Adrian P. Heymer
EXECUTIVE DIRECTOR
STRATEGIC PROGRAMS

Subject: Submittal of NEI 12-02, Revision 0, Industry Guidance for Compliance with NRC Order EA-12-051, "To Modify Licenses with Regard to Reliable Spent Fuel Pool Instrumentation" and Comments on NRC Interim Staff Guidance Compliance with Order EA-2012-051, Reliable Spent Fuel Pool Instrumentation (JLD-ISG-2012-03) (77 Fed. Reg. 33780; Docket ID NRC-2012-0067)

NEI 12-02 [Revision 0]

**Industry Guidance for
Compliance with NRC
Order EA-12-051, “To
Modify Licenses with
Regard to Reliable Spent
Fuel Pool
Instrumentation”**

Figure 1

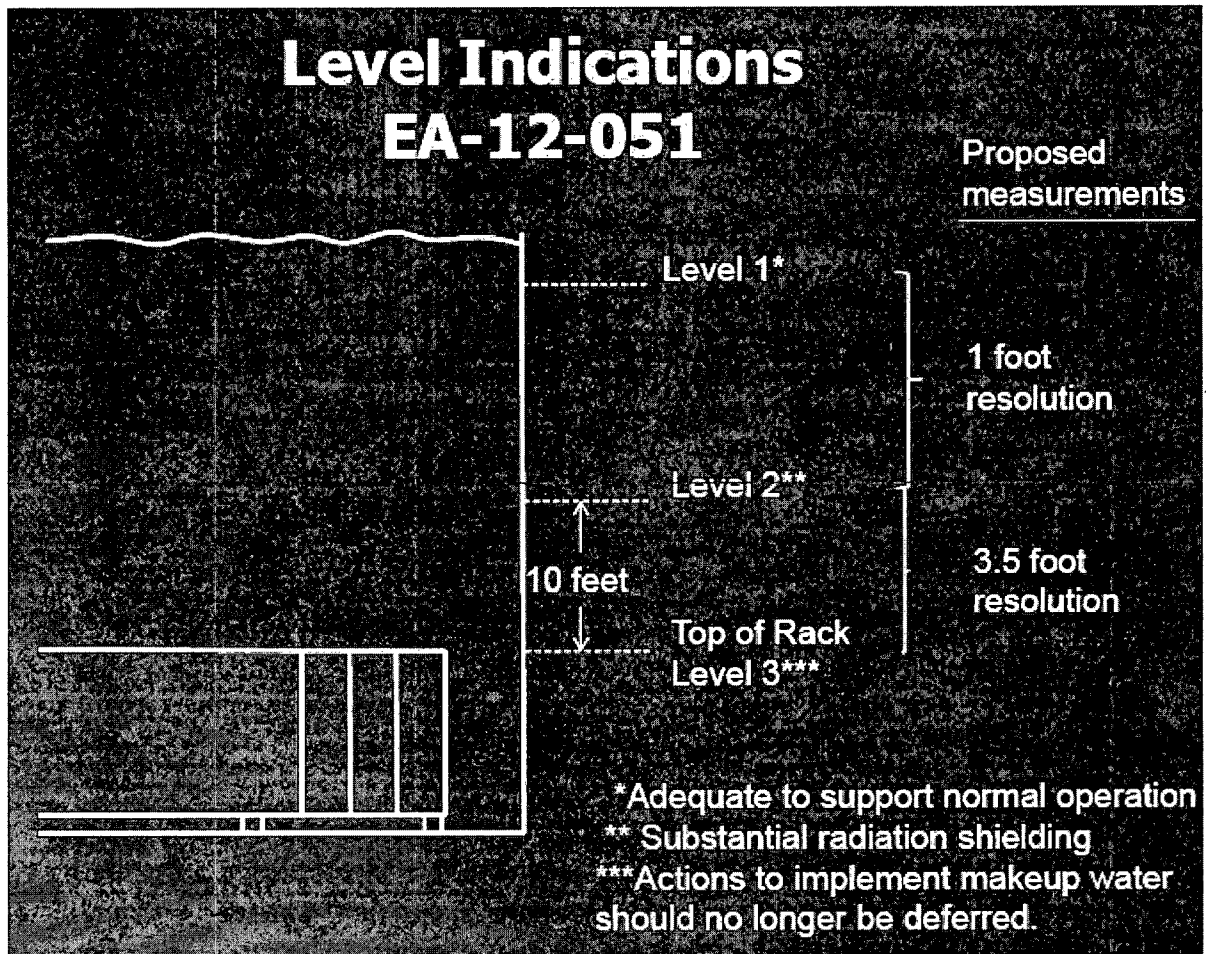
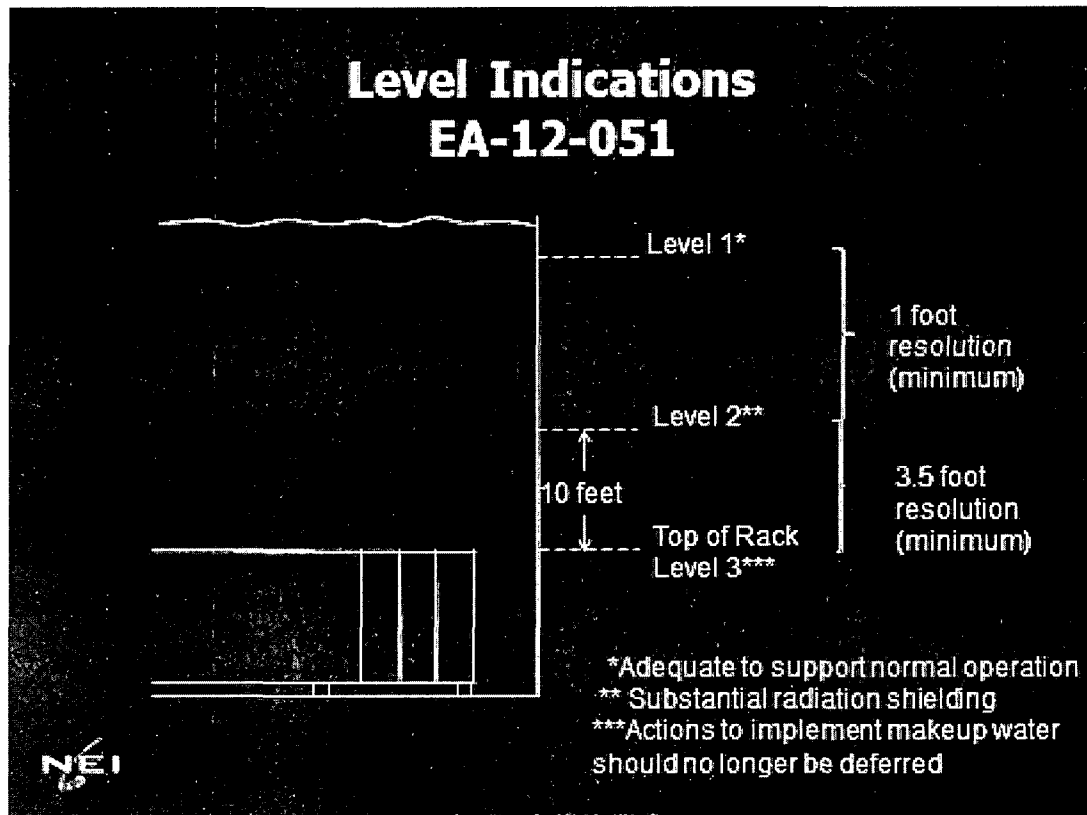
The three critical ~~points~~levels that must be monitored in a spent fuel pool are discussed below. It should be noted that continuous indication from a single instrument over the entire span from ~~PointLevel~~ 1 to ~~PointLevel~~ 3 is not required, but the set of instruments used to monitor the entire span is necessary to satisfy the requirements for the primary or backup instrument channel (refer to Figure 1 below).

A visual representation of ~~the monitoring level points~~levels 1, 2, and 3 and the associated resolution requirements for monitoring between the points are presented in Figure 1. The minimum resolution requirements apply to the separation distance between level indications and support development of appropriate response procedures. These requirements are separate from the instrument channel design accuracy discussed in section 3.
